SUFFIELD BUILDING CODE BOARD OF APPEALS MEETING MINUTES

MEETING FOR THURSDAY MAY 13, 2021 - 7:00 PM

**Opening of Hearing/Reading of the Complaint:** Appeal of a decision by the Suffield Building Official to deny a building permit application to construct a single-family residence at 14 Kings Meadow Lane (Lot 17), Suffield, Connecticut.

17 Kings Meadow Lane  
Suffield, Connecticut  
DA Project No. 2020-073

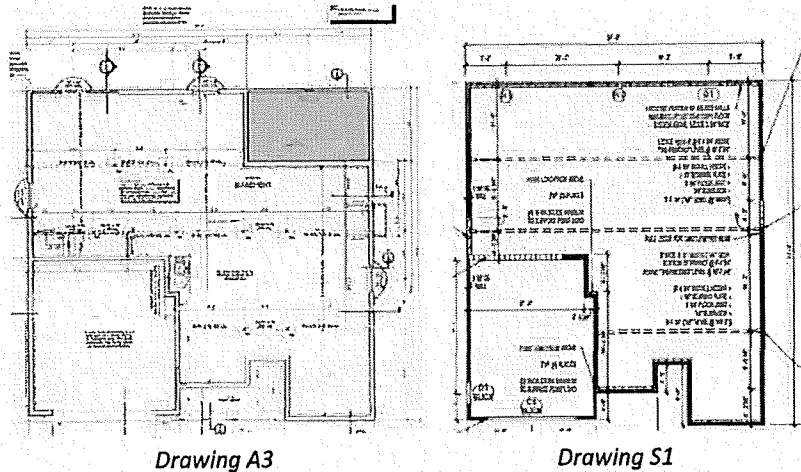
3. The allowable loads governed by deflection that are contained in CERus-1002 are significantly higher ( $\pm 19\%$ ) than those tabulated in the reports that had been previously submitted; an explanation for this improved performance should be provided.
4. On Drawing S1, the requirement for waterproofing of the wall panel walls has been added. This addresses Section 4.3.2.1 of QAI CERus-1002 that indicates that when using Greenstone ICE panels as foundation walls, the design shall consider "methods for protection of the steel elements from potential corrosion effects of soil moisture in event of dampproofing or waterproofing material failure."

### **3.QAI Response:**

I believe this comment is regarding the change in CERus-1002 load capacity tables from previously submitted Sumner Engineering load capacity information provided. The original Sumner Engineering load capacity tables were developed for use in Canada, following Limit States Design (LSD) methodology as required for use in Canada, with a resistance factor determined by Sumner engineering based on this approach.

CERus-1002 as noted above, used the LRFD methodology based on load testing as noted above. As such, this change in methodology from LSD to LRFD lead to different calculated design strengths. It should be noted, to err on the side of conservative the load at deflection points noted in CERus-1002 had an applied resistance factor included.
